ADDENDUM No. 3

Date October 5, 2016

Project Name Taylor Lane 0.1 MGD Wastewater Treatment Project

C.I.P. No: 3353.095 IFB No.: IFB6100 CLMC600

DWG. NO.
M-4
SHEET **46** OF **79**

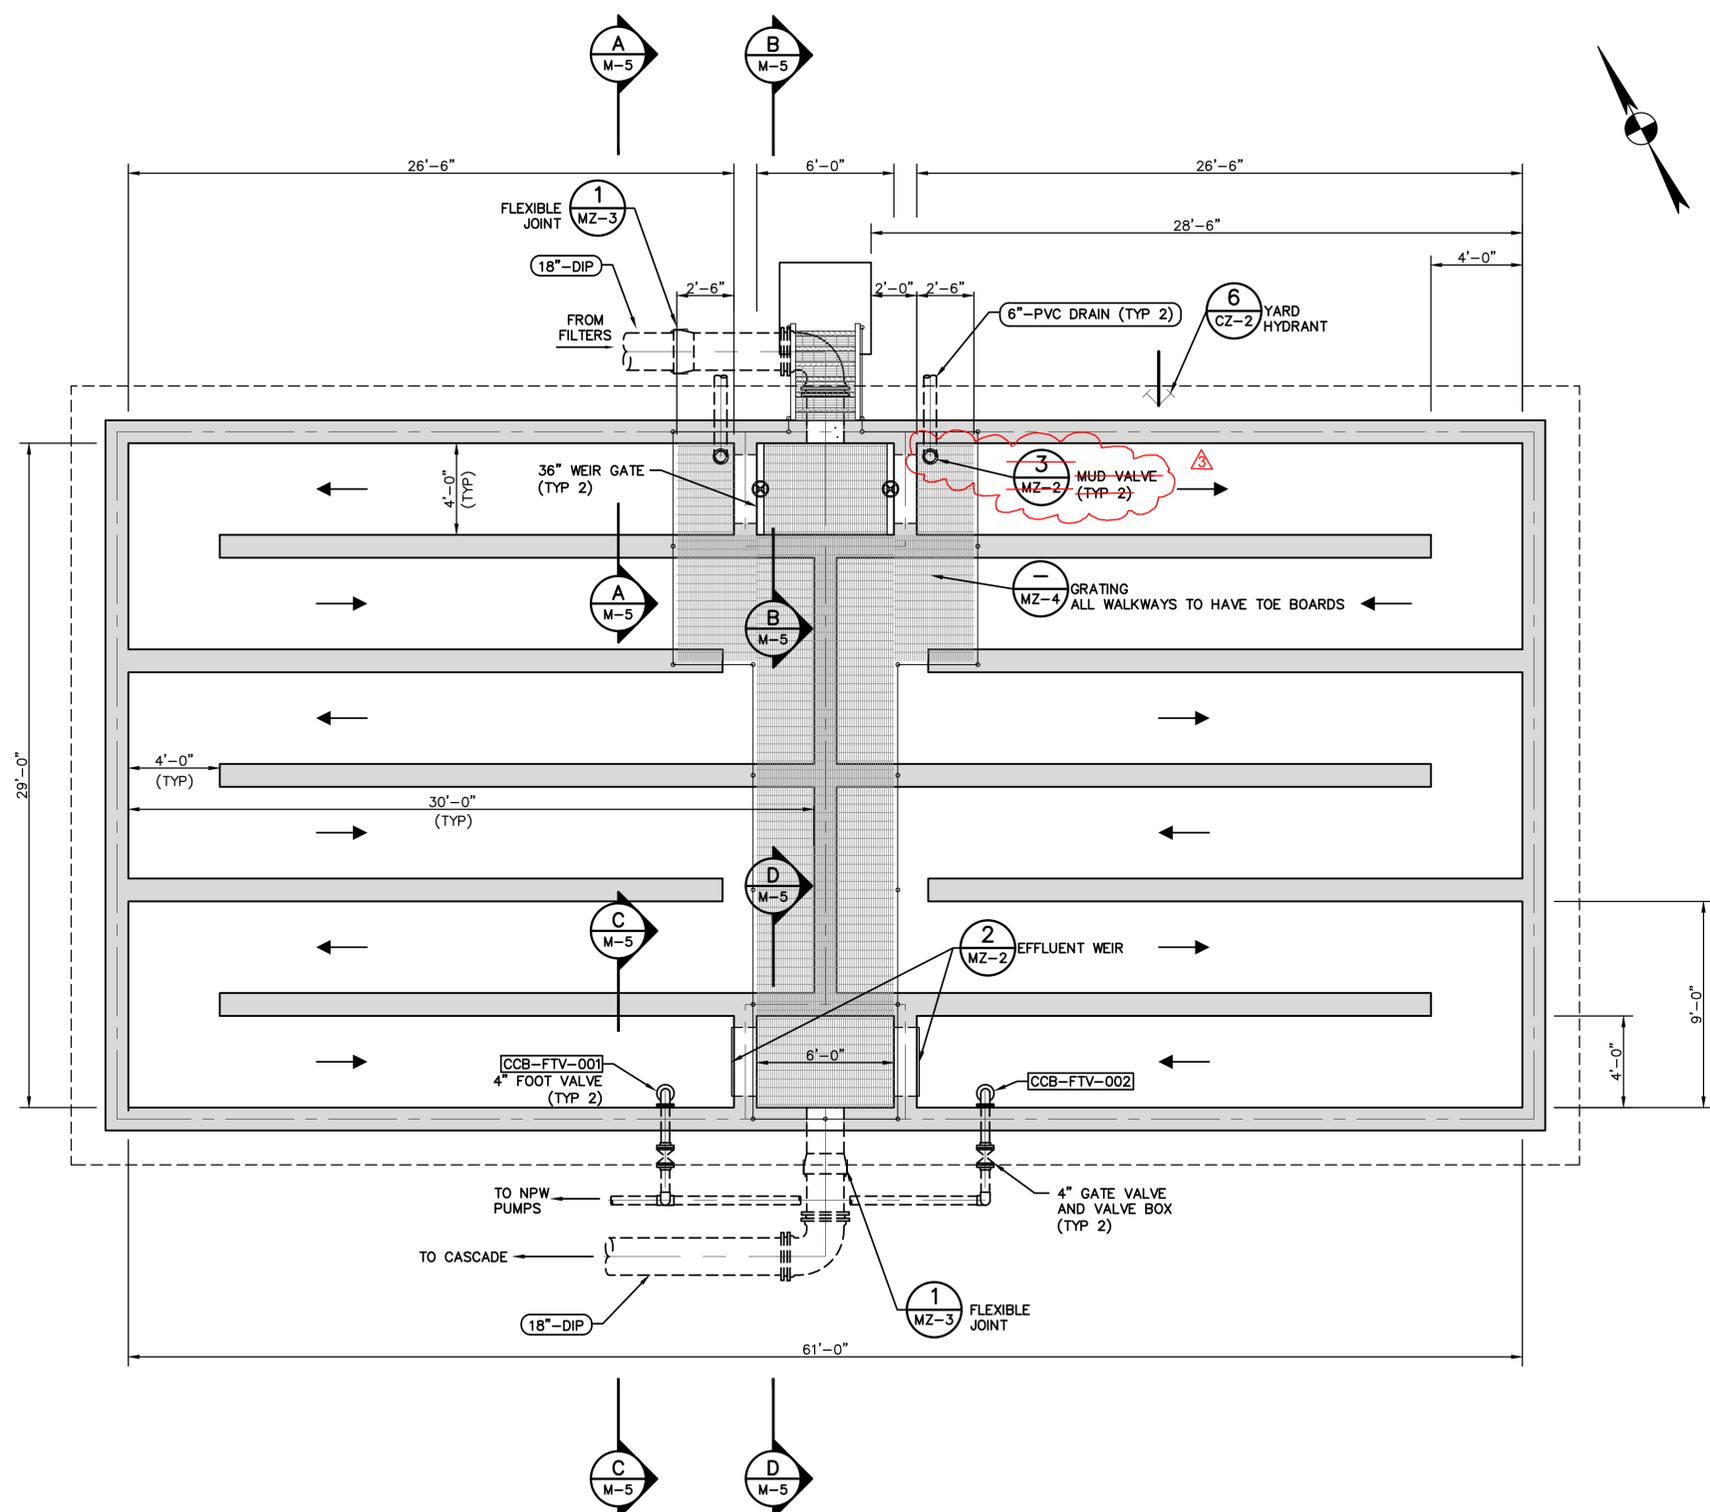
Replace Sheet M-4 with attached

REV	DATE	BY	DESCRIPTION	APPROVED
ADD 3	OCTOBER 5, 2016	SST	ADDENDUM NO. 3 REMOVED MUD VALVE
